Tice River Homes
Legacy

model
36-04

project #
17052

A1

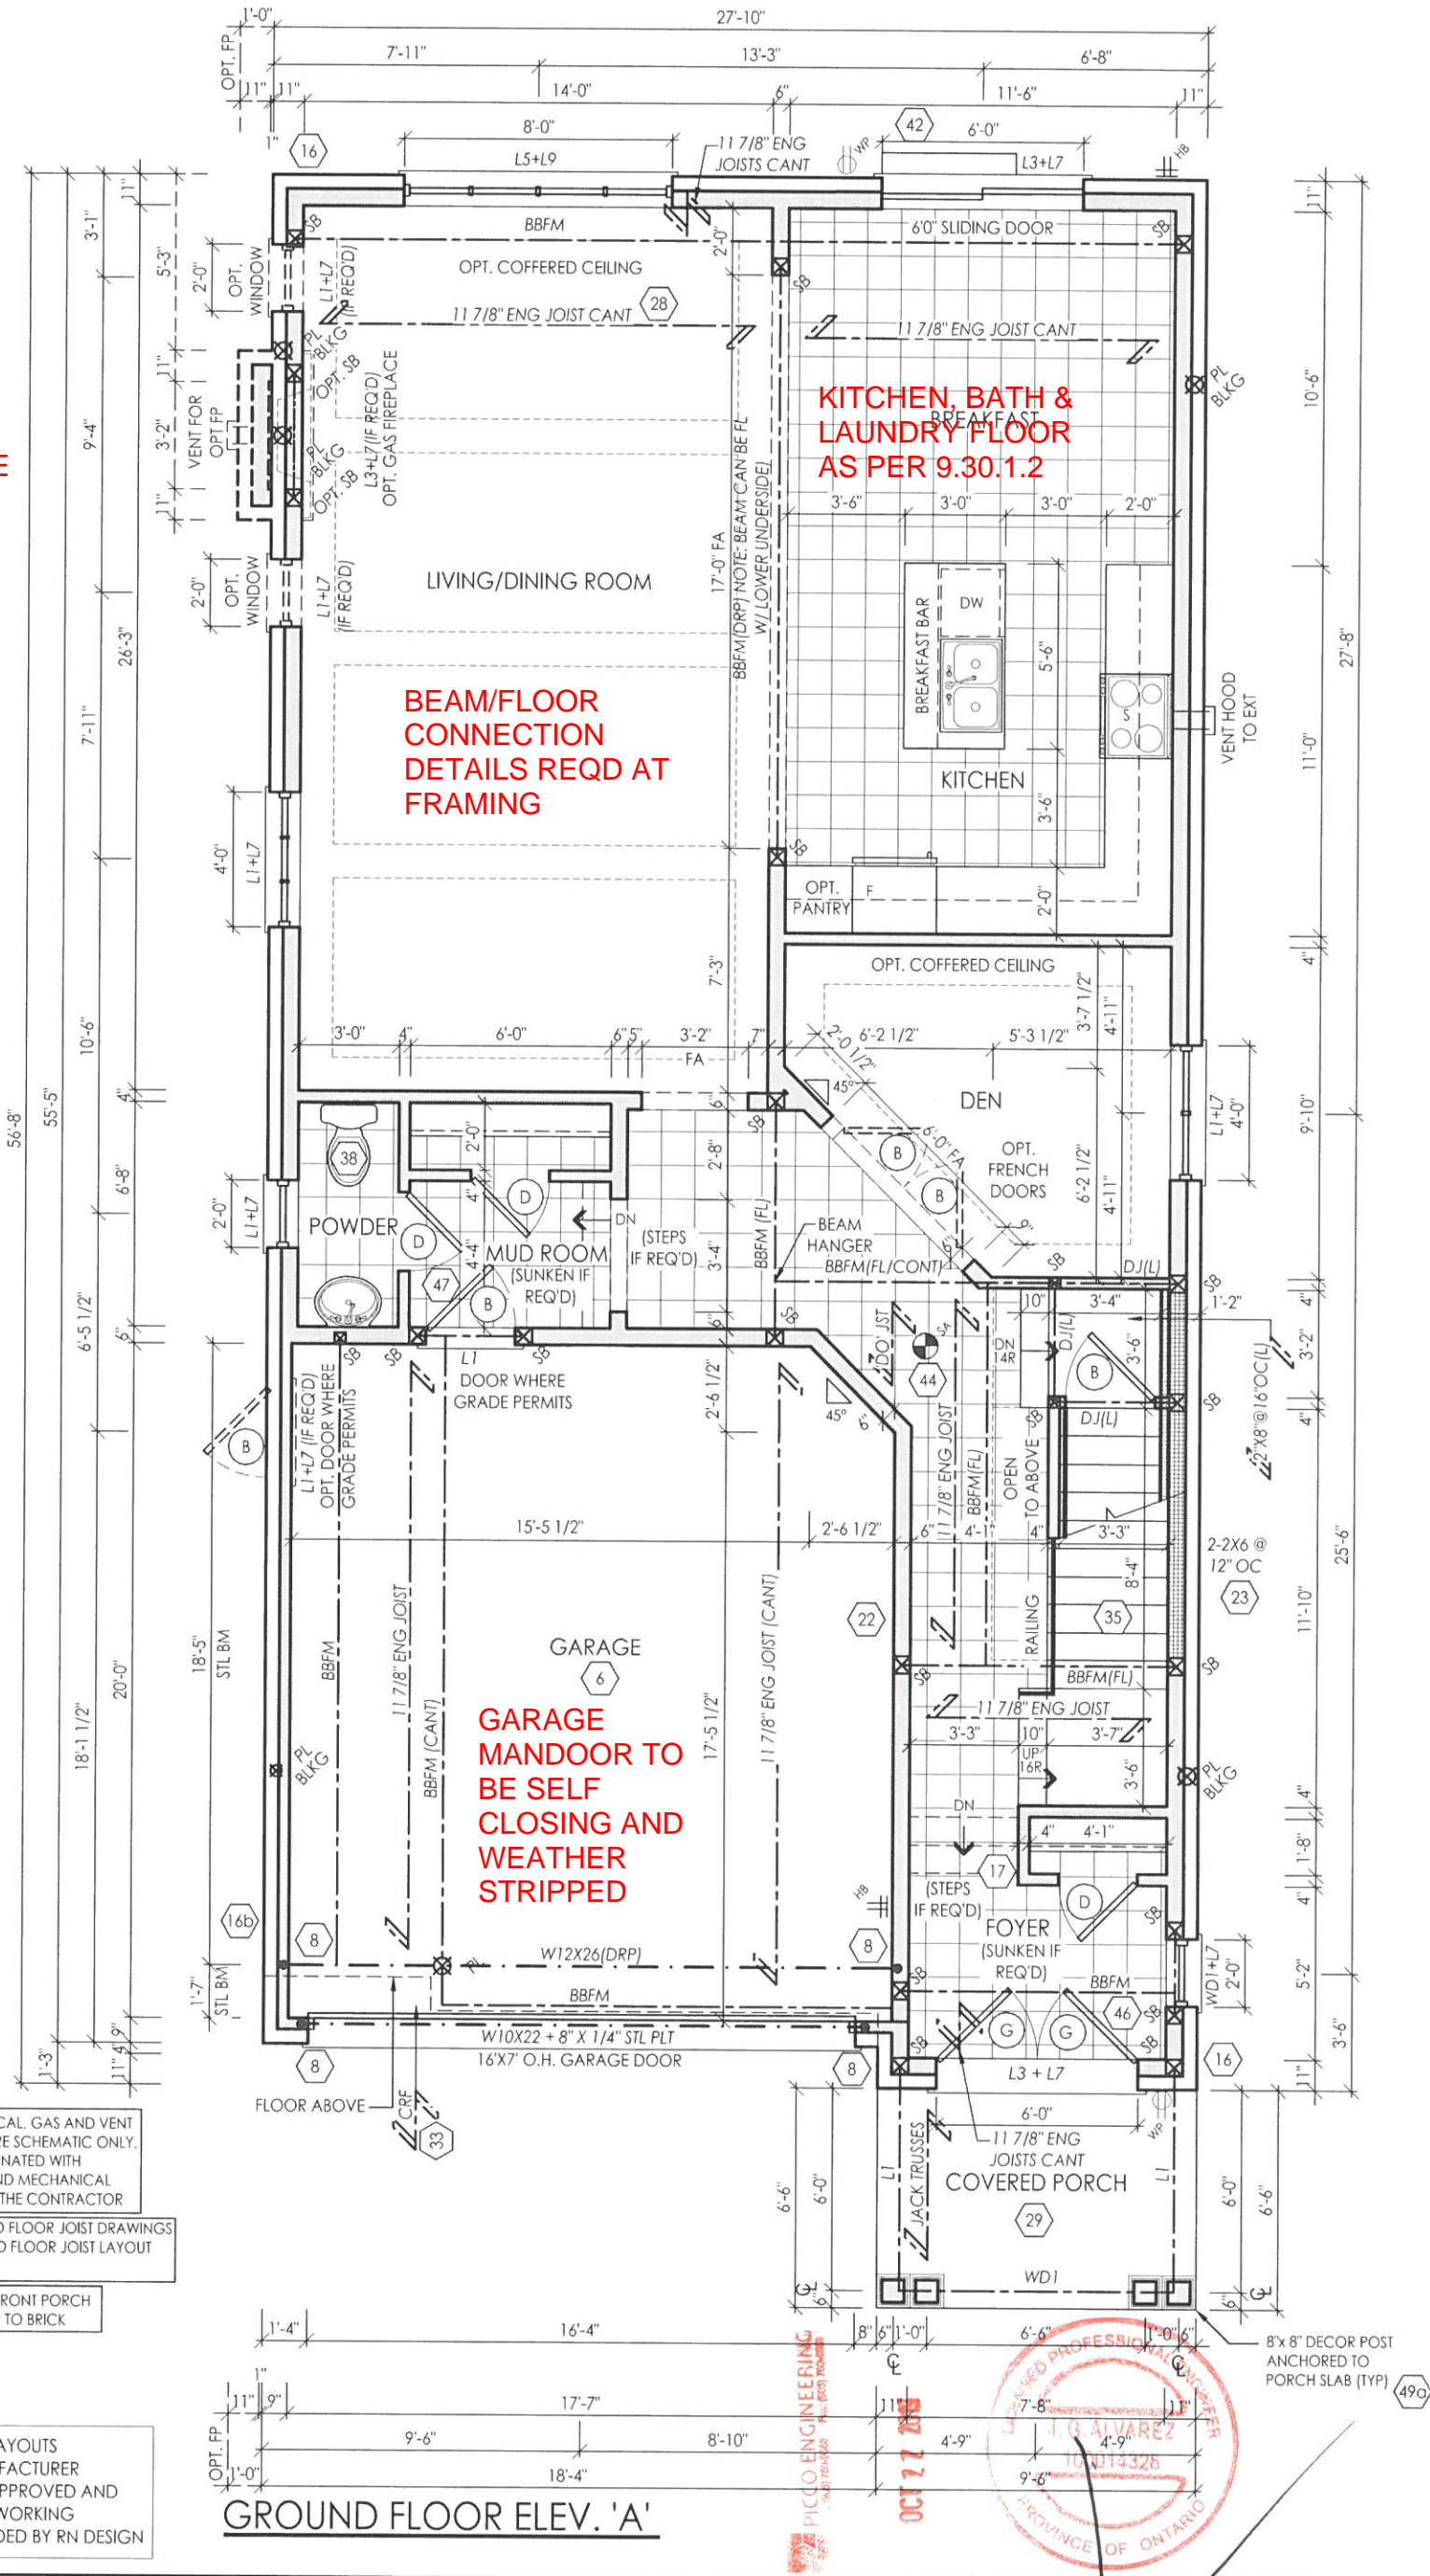
6'11" CEILING
HEIGHT REQD
OVER 75% OF BSMT
SPACE AS PER 9.5.3

NOTE: REFER TO FLOOR JOIST DRAWINGS
FOR APPROVED FLOOR JOIST LAYOUT
AND SPACING

SECOND FLOOR ELEV. 'A'

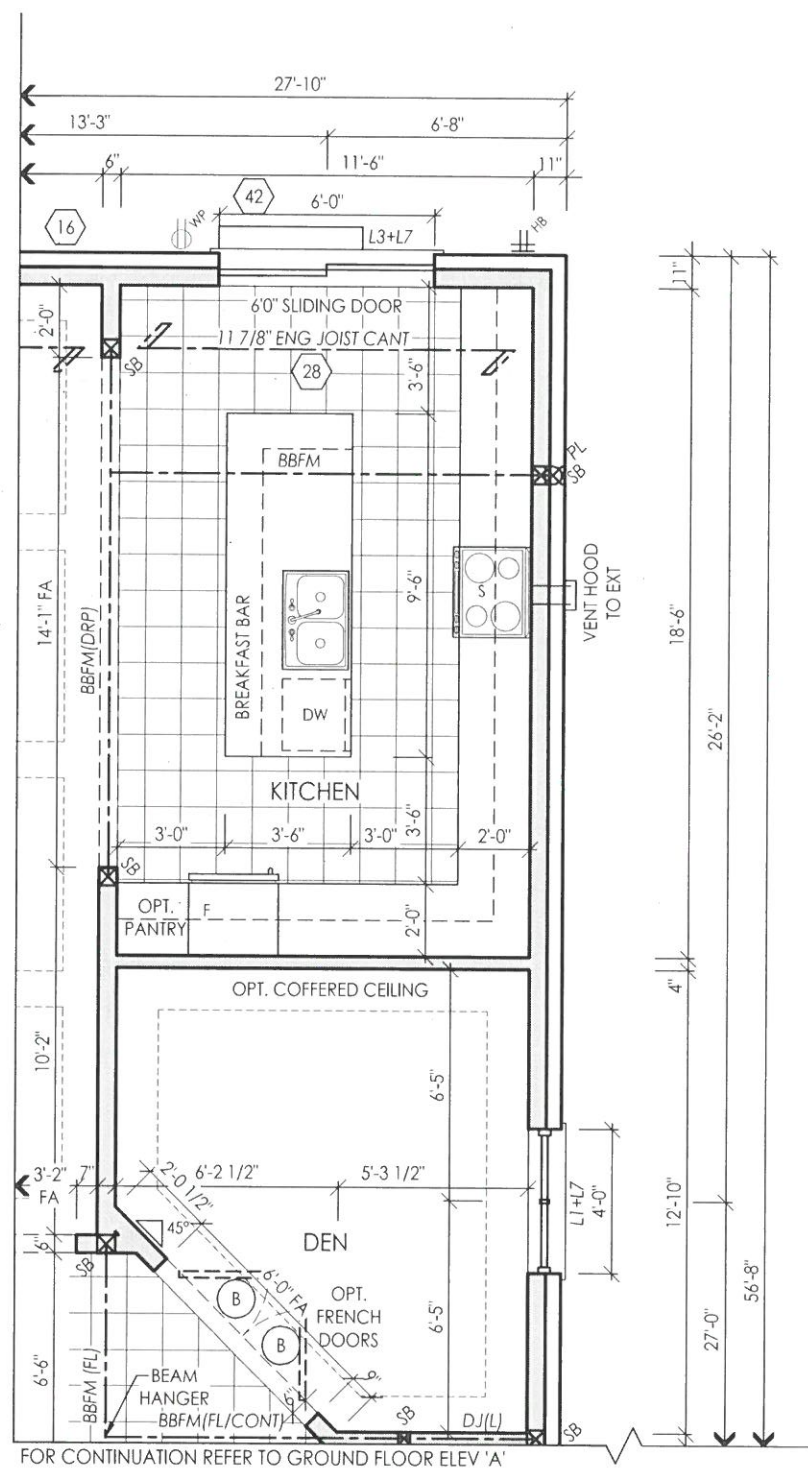
ENGINEERED FLOOR LAYOUT, TRUSSES AND LINTELS TO BE SUBMITTED PRIOR TO FRAMING. DESIGNER TO COMPLETE RESPONSIBILITY REVIEW FORM AND TO BE SUBMITTED WITH TRUSS, FLOOR AND LINTEL DOCUMENTS.

MAIN BATH TO HAVE GRAB BAR BLOCKING

WINDOW ON LANDING MUST BE HIGHER THAN 3' ABOVE OR ENGINEERING ON WINDOW OR GUARD REQD

ALL POINT LOADS TO BE TRANSFERRED TO FDN
